Castle Street, Banbury

Flood Risk & Drainage Technical Note

| Revision | D (Changes Highlighted) |

1.2 This technical note has been revised to take account of Oxfordshire County Council's consultation response for this application (21/04202/F) dated 25 May 2022, specifically related to comments received from the Lead Local Flood Authority (LLFA) dated 20 April 2022 (included in Appendix M for ease of reference). The latest comments follow on from previous comments from the LLFA, dated 25 February 2022 (included in Appendix L as per the previous revision of this technical note). Further revised content has been highlighted for ease of reference and a summarised response provided within the concluding section of this report.

Appendix H Preliminary Drainage Layout

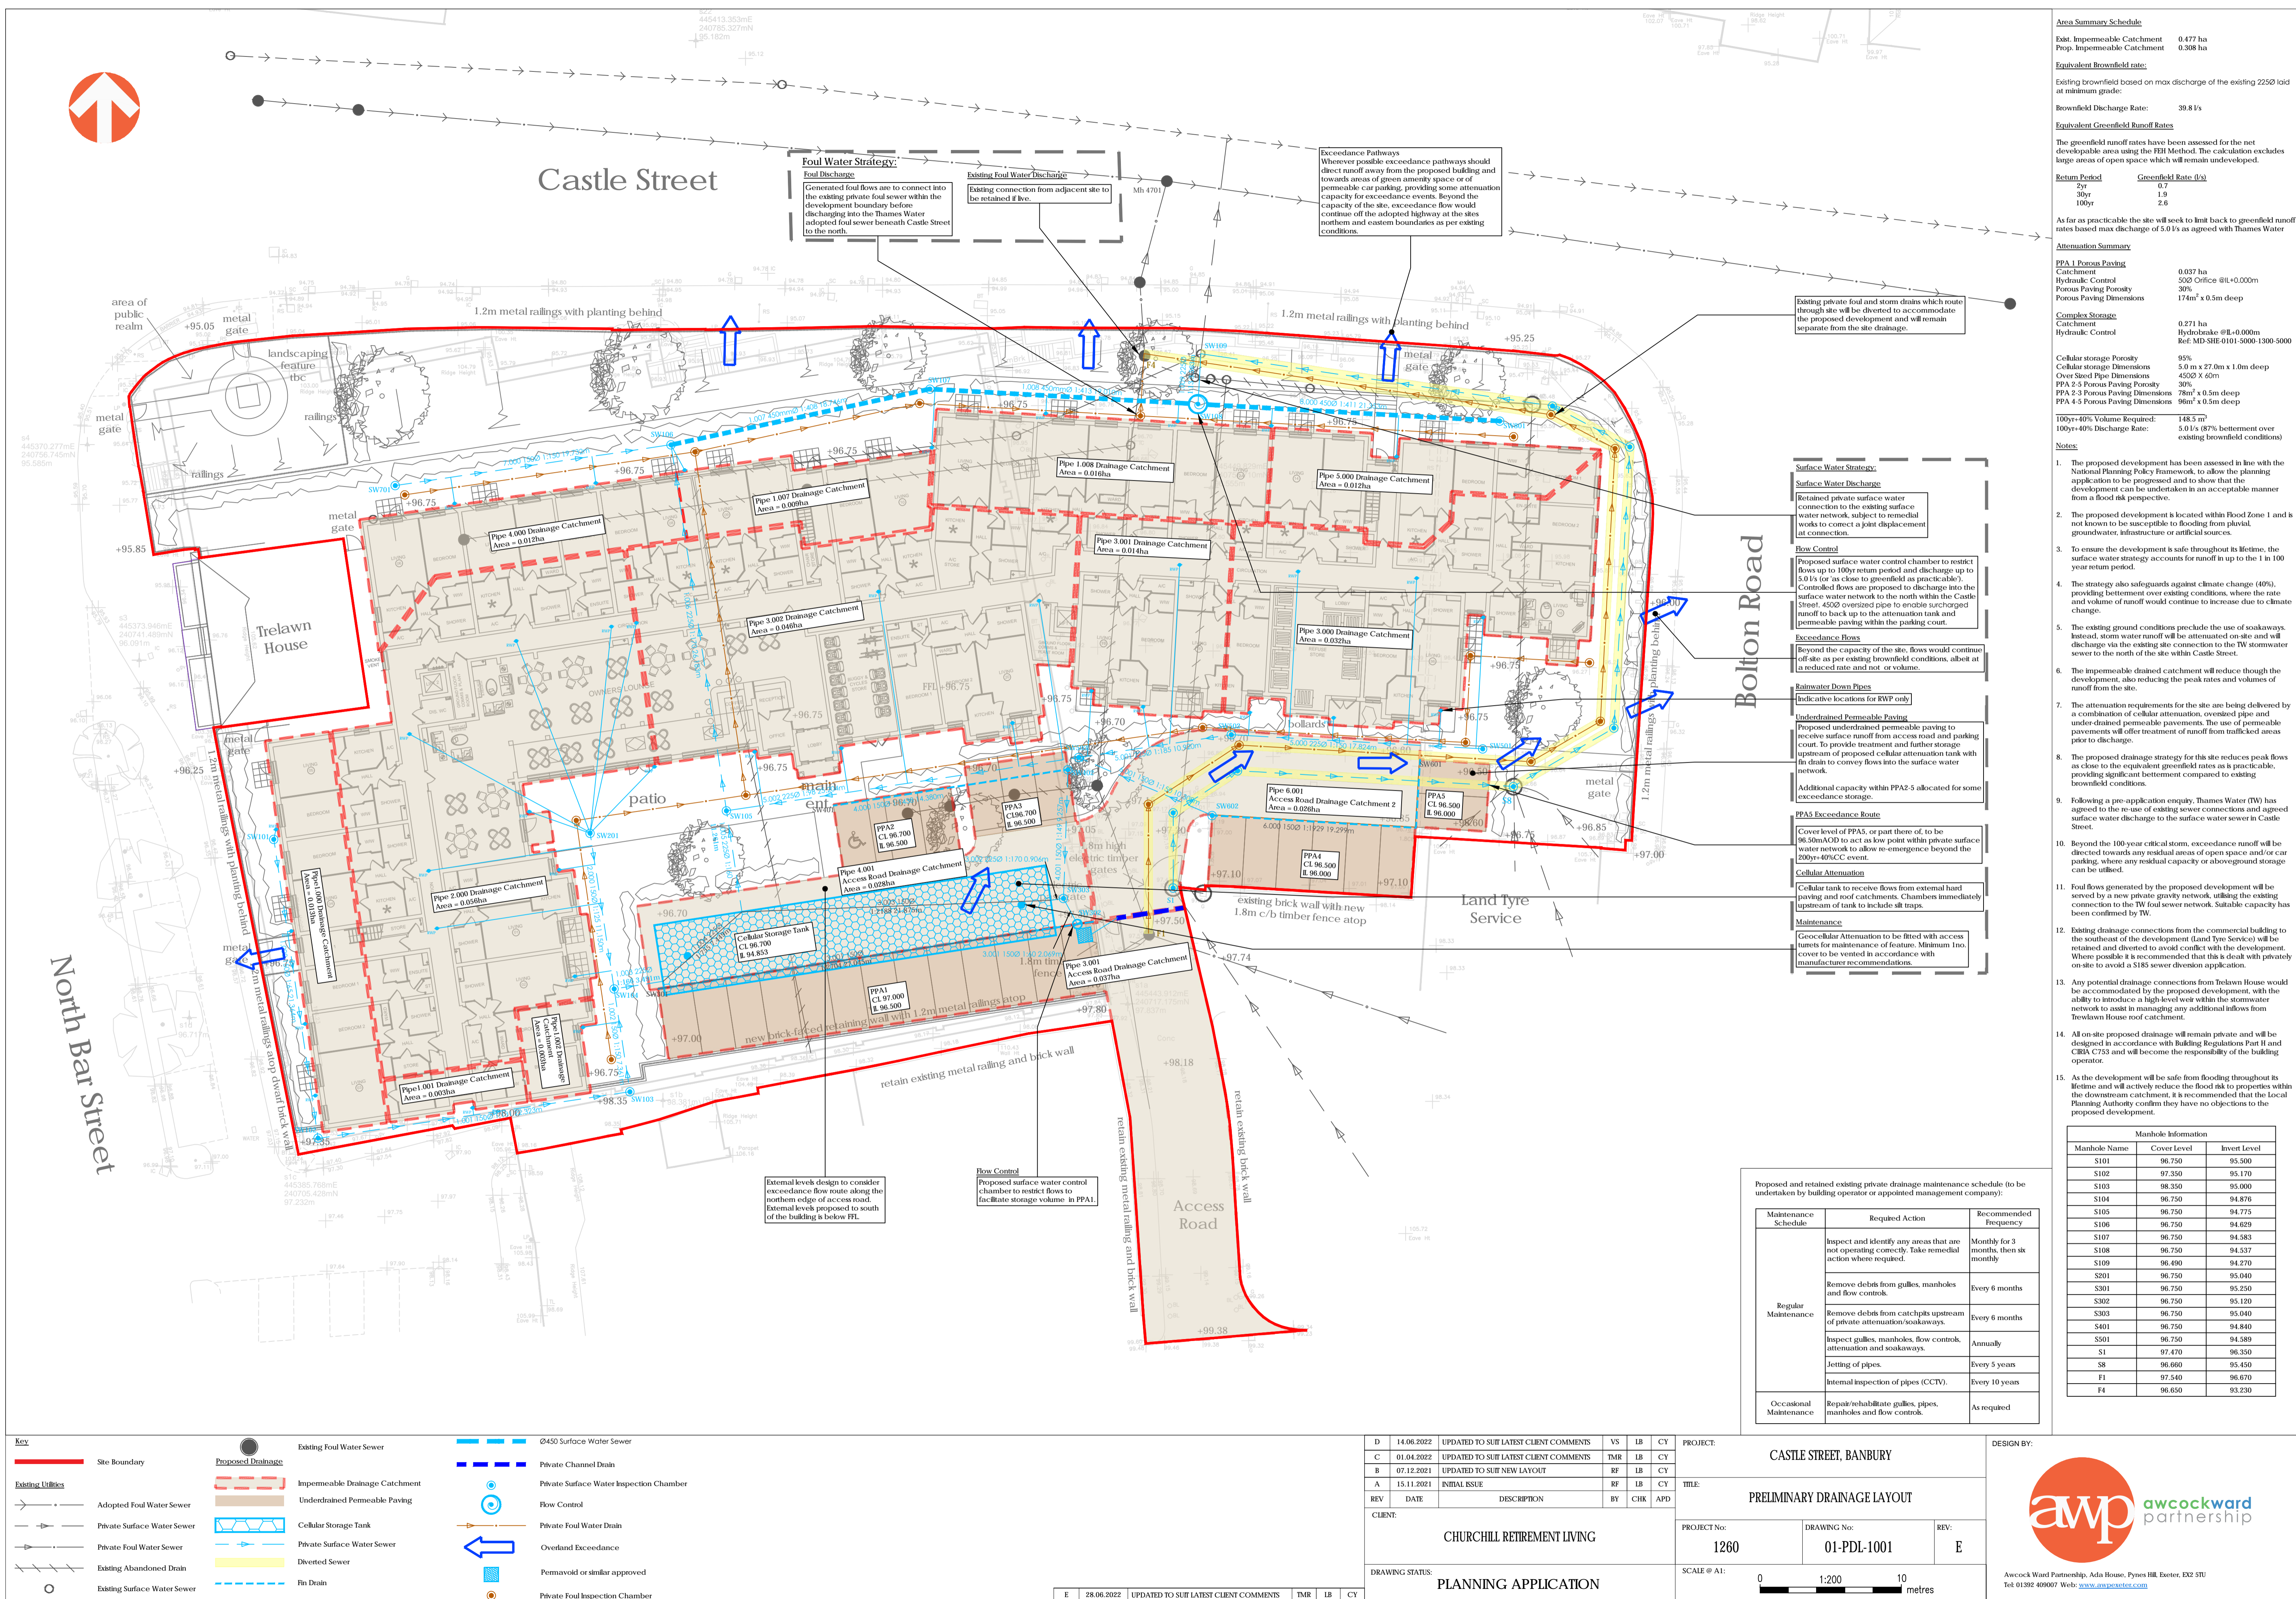
As part of a full application drawings and calculations are expected to be detailed. Drainage strategy drawing should show invert and cover levels for all proposed drainage infrastructure and SuDS feature. All surface water pipes needs to be numbered and sized which should correlate with the Microdrainage calculations. Calculations required for the whole surface water network.

Existing drainage to be shown on drainage strategy drawings. Existing pipes that are being retained should be clearly identified. Also all the maintenance requirements for the existing retained pipes needs to be identified on plan drawings.

Surface water exceedance plan to be provided to demonstrate how the site will drain in an event where the surface water network fails. All surface water should be kept away from structures and within the site boundary.

As part of a full application drawings and calculations are expected to be detailed. Drainage strategy drawing should show invert and cover levels for all proposed drainage infrastructure and SuDS features. Attenuation tank and permeable paving details not provided. The tank and permeable paving details should reflect the calculations.

Surface water exceedance plan to be provided to demonstrate how the site will drain in an event where the surface water network fails. All surface water should be kept away from structures and within the site boundary, currently some of the flow arrows shows surface water leading outside the side boundary. How is the surface water being picked up in these areas.

- 8.4 *Existing drainage not shown on the drainage strategy drawing.* All the existing drainage, to be abandoned, has now been included on the updated PDL (Appendix H).

- 8.5 *Remedial works for existing drainage pipes not identified on plan drawing.* Remedial work at point of connection with the surface water network now noted on the updated PDL (Appendix H).

- 8.12 *Drainage strategy drawing not detailed.* Surface water network details, now including cover and invert levels for attenuation features included on the updated PDL drawing (Appendix H). Surface water strategy network model updated to suit most up to date levels with modelling output provided in Appendix G.

- 8.14 *Surface water exceedance plan.* The attenuation design provides additional capacity for the management of exceedance events. The residual capacity within the under-drained permeable paving can be accommodate up to the 1 in 200 year, with 40% climate change, beyond which there would be some localised ponding within areas of green space and parking bays. Beyond the capacity of the site, external levels have been adjusted to direct exceedance runoff, to the south of the building, to flow east towards the eastern boundary. External works and landscaping within the site and along the site boundary will accommodate exceedance flows as far as possible. Beyond the limits of the site, exceedance flows would continue to the northern and the eastern boundaries and towards Castle Street as per existing conditions. However, the likelihood of exceedance runoff from the site is significantly improved when compared to the existing conditions (See par 4.16, 4.18 & 4.22).

Appendix I Existing Impermeable Areas Plan

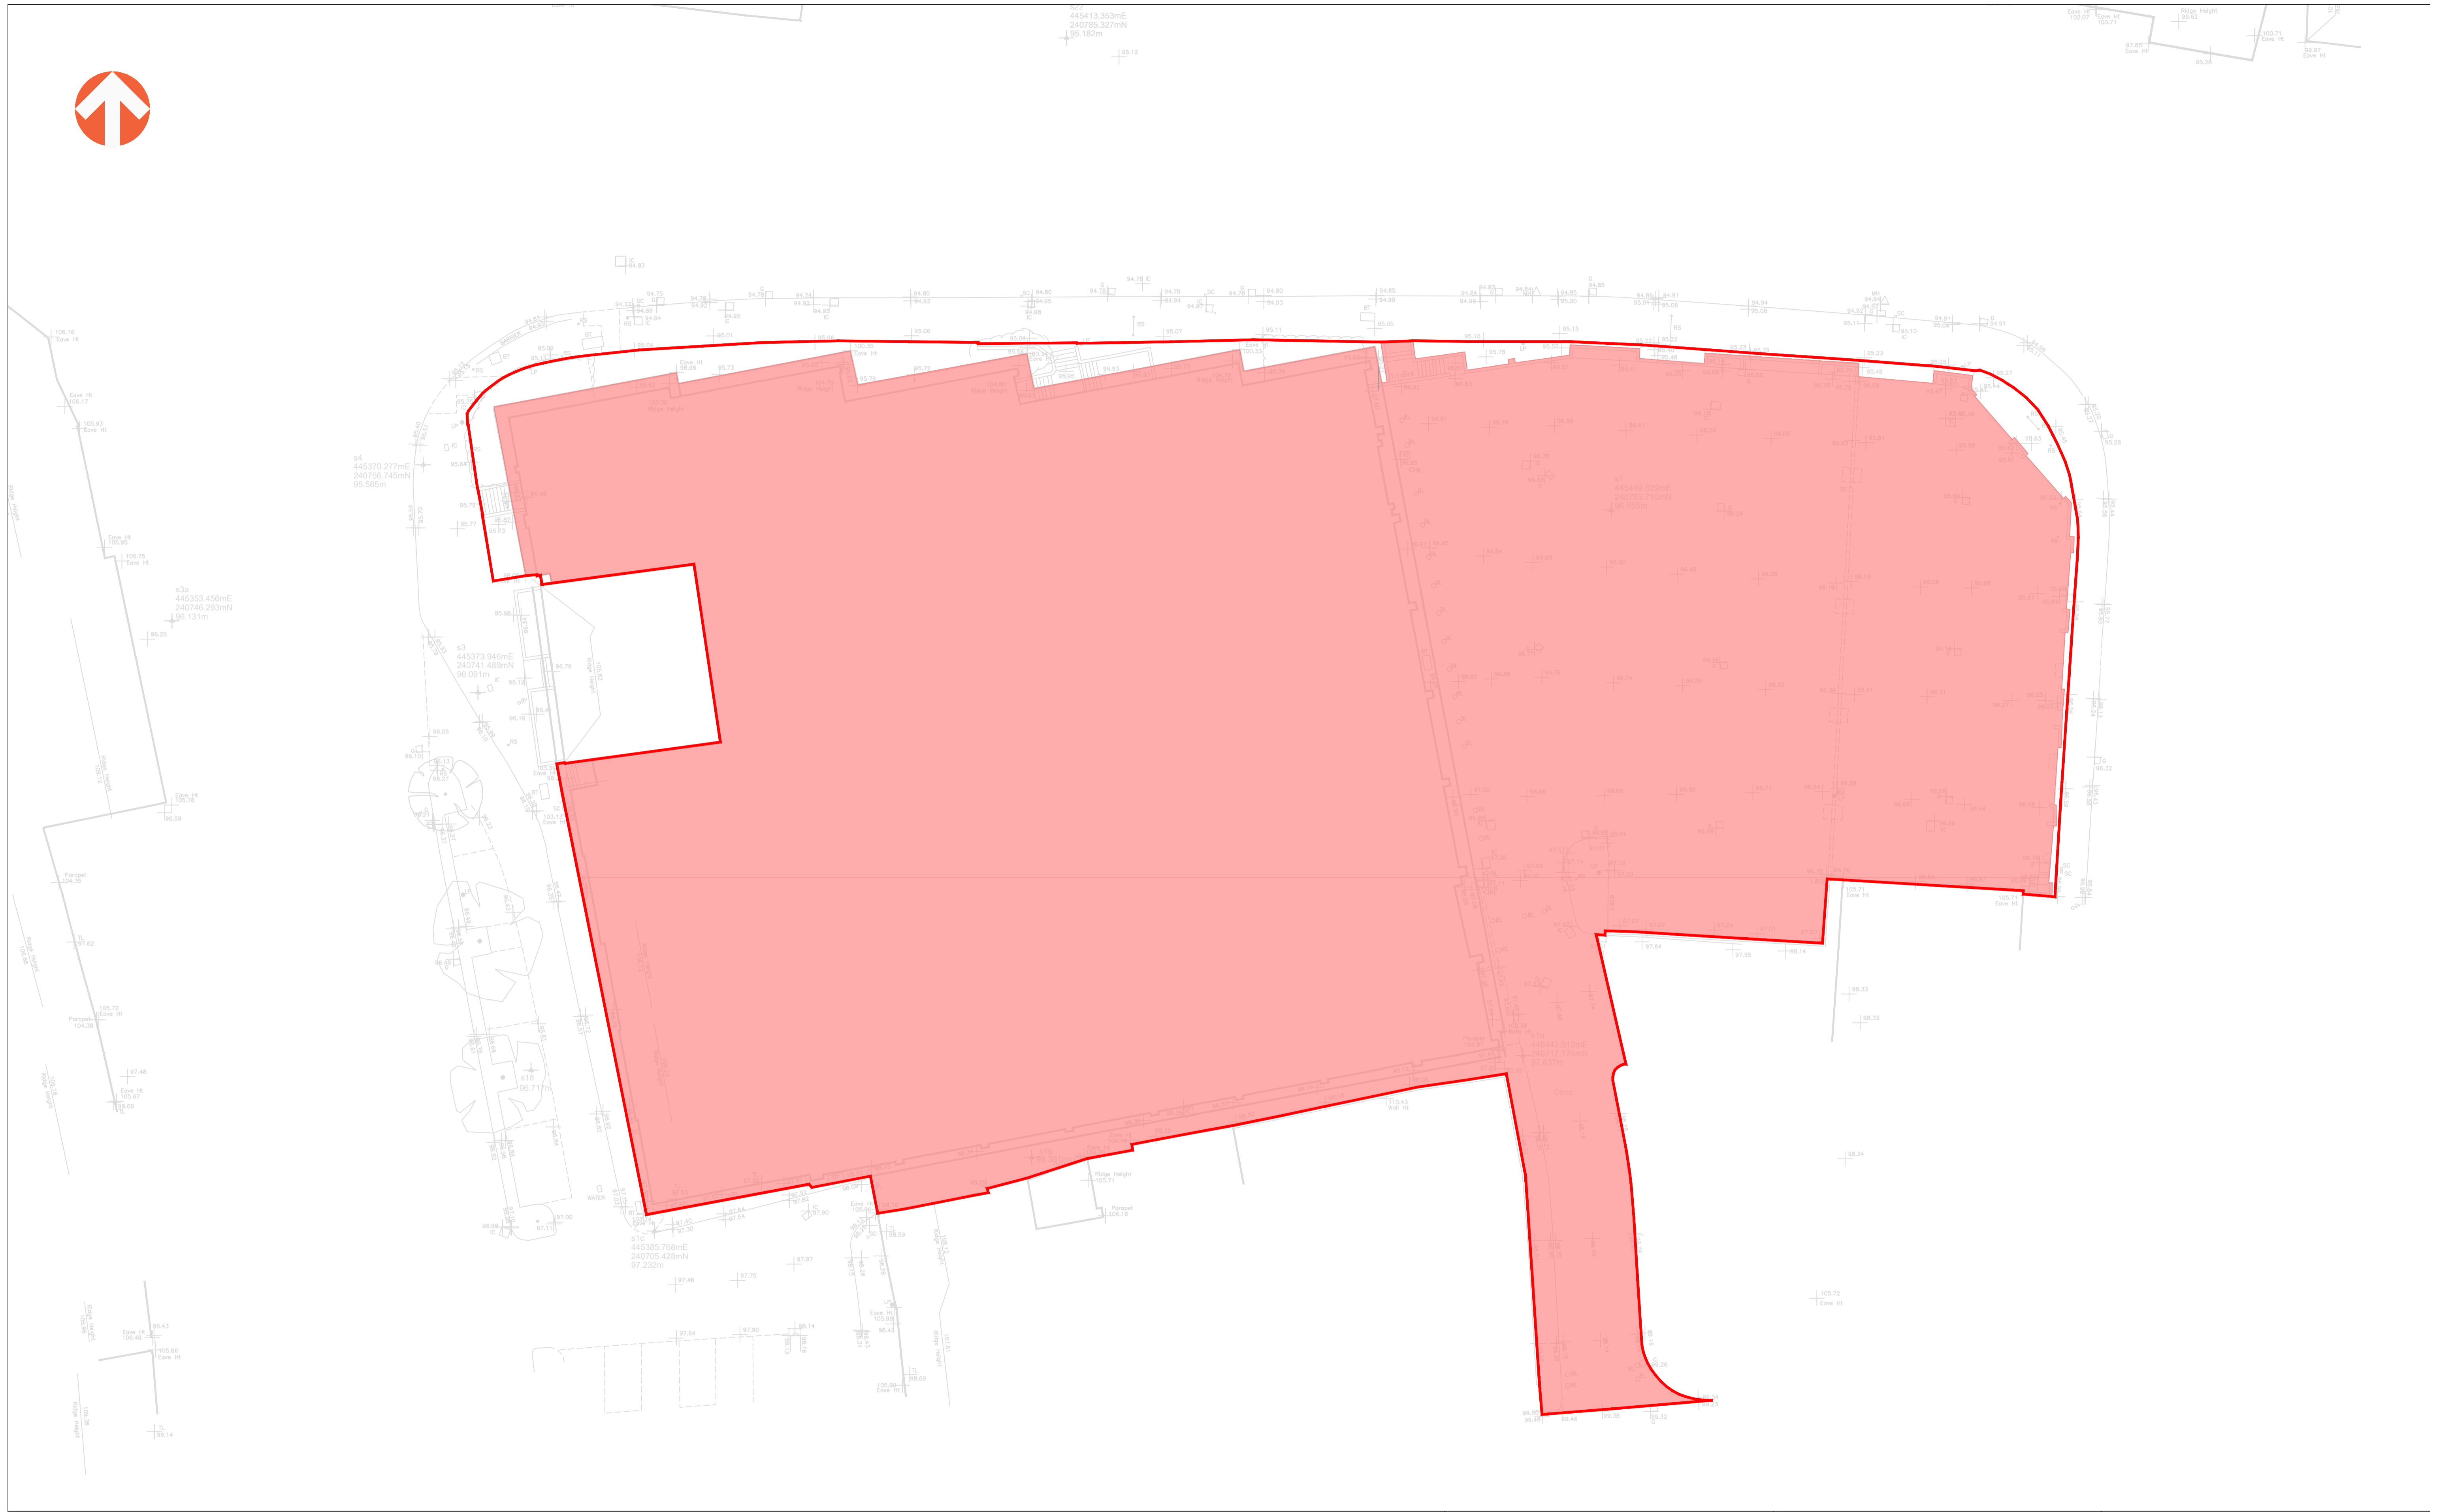
Surface water catchment plan required to demonstrate how the site will drain and to which drainage features. The proposed areas needs to be clearly shown and the existing areas.

Surface water catchment plan required to demonstrate how the site will drain and to which drainage features. The proposed areas needs to be clearly shown and the existing areas. The impermeable area on the catchment plan is different to the area used in the calculations. Please clarify. The catchment plan should also show the area going into the proposed surface water network.

- 8.6 *Surface water catchment plan not provided.* An 'Existing Impermeable Area' plan has now been provided (Appendix I). The impermeable catchment areas for the proposed development are now indicated on the updated PDL (Appendix H).

- 8.13 *Surface water catchment plan.* The surface water catchments are shown on the PDL drawing (Appendix H). The total area drained is 0.308ha as stated in the PDL summary notes. Individual catchment areas have been annotated, together with which pipe they are draining to in the network model. It should be noted that some pipe runs receive flow from multiple areas. The text has been made clearer on the PDL drawing.
